<b>Subject:</b> <b>RATTLE / VIBRATION NOISE FROM RIGHT REAR OF VEHICLE</b>	<b>Bulletin No:</b> 09-022/13
	<b>Last Issued:</b> 07/31/2013

2013 CX-5 vehicles equipped with theft-deterrent with VINs lower than JM3 KE\*\*\*\*\* 169135 (produced November 19, 2012)

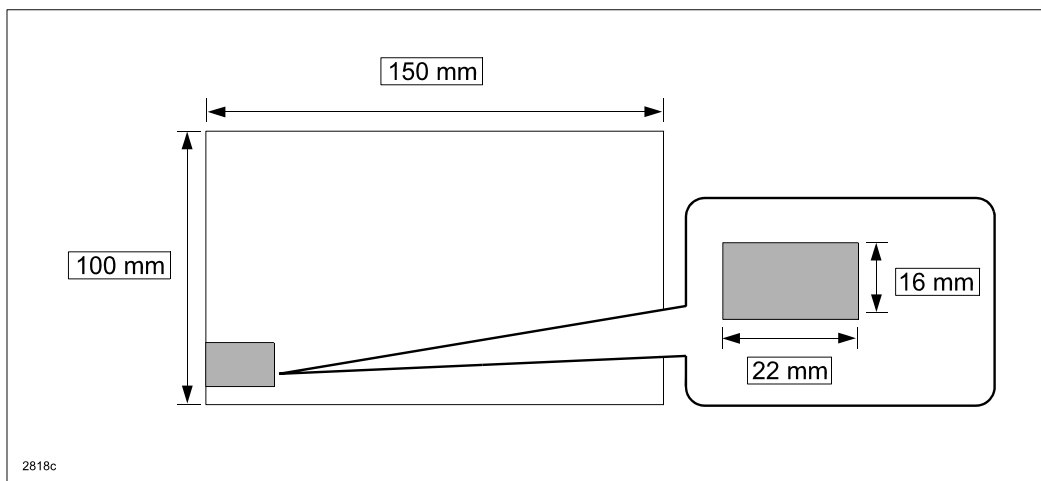
**NOTE:** It is necessary to disconnect the connectors (LH: cargo room light connector, RH: rear accessory socket connector) when removing the Trunk Side Trim.

4. Remove the theft-deterrent horn according to the instructions on MS3 online or the Workshop Manual (section 09-14 THEFT-DETERRENT HORN REMOVAL/INSTALLATION).
5. Obtain a sheet of 3mm thick non-woven fabric from the "Noise Repair Kit".
6. Cut one (1) piece of fabric to 16mm x 22mm.

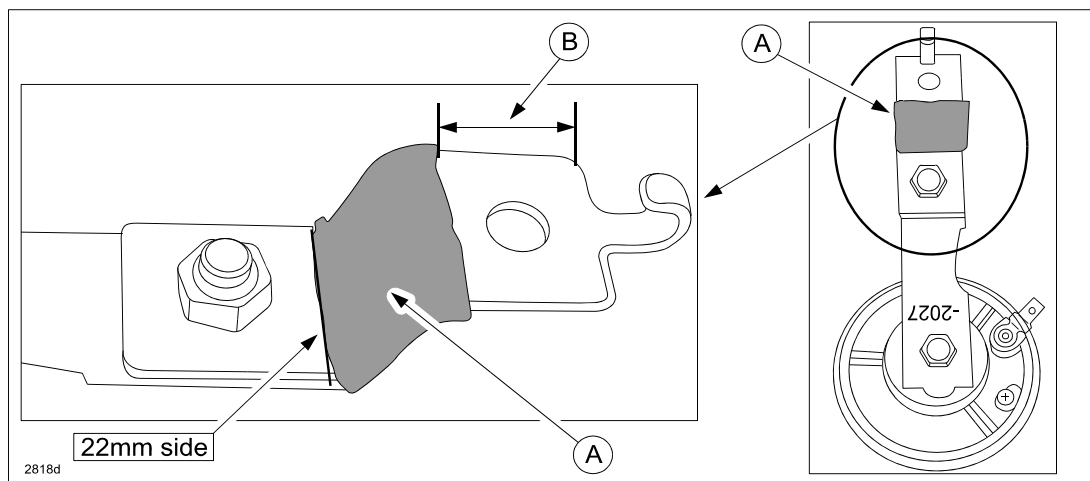
7. Affix the fabric (A) onto the horn bracket 20mm (B) away from the edge of the bracket. Place the 22mm side of fabric as shown below.

**NOTE:** The fabric is a damper, which is why it needs to extend well past the point where the bracket makes contact with the body. There should be a slight overlap of fabric under the clamping surface.
